Source:	Prestolite Electric Ltd - Greenford, London, UK
Date:	September 29, 2020
Bulletin No:	TSB4080
Models:	MS4 series
Subject:	Supersession fitment information.

## SUPERSESSON INFORMATION

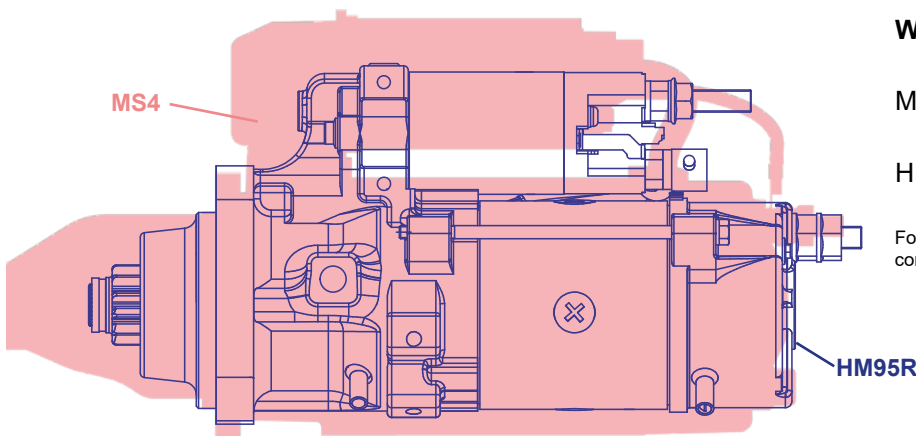
The MS4 series of starter motors have been superseded by HM95R type starters.

The HM95R starter motor is a modern gear-reduced starter with a noseless design and offer smaller, lighter design for increased output performance characteristics.

This makes the starter easier to handle and install compared to the older MS4 design.

See illustration below of size comparison.

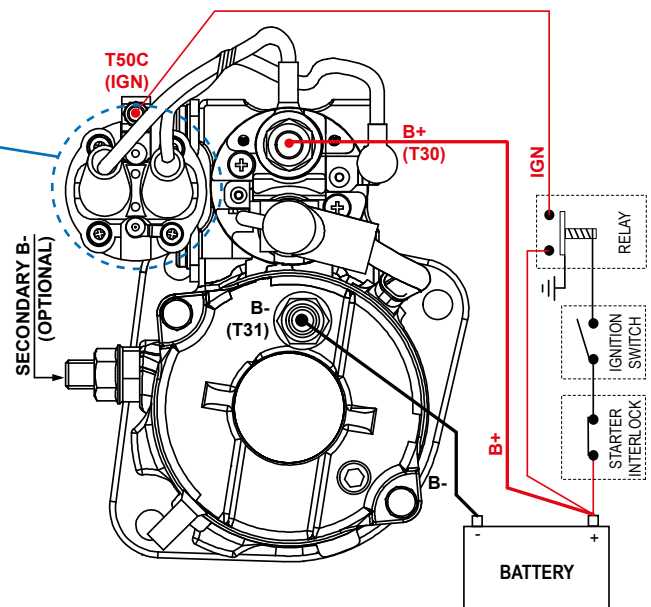
The HM9R is fitted with a control relay.

Under no circumstances must this control be removed or electrically by-passed.

Ignition (switch) connection is made on the control relay. See adjacent wiring diagram.
